Access Compliance Report Public Rights-of-Way (Curb Ramps)

Intersection ID: 30323 Main Street: SHINKANSEN_DR Cross Street: STOURBRIDGE_LION_DR Location: W

ADA ID: 27E50658603F Ramp Type: BlendTrans1 Initial Pass/Fail: Fail Overall Compliance: No Severity Score: 10

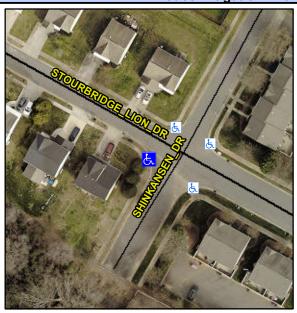
RP < 5%

Not Found, R304.5.1, R304.5.3

Remove & Replace Curb Ramp With Two New Directional Ramps or Equivalent.
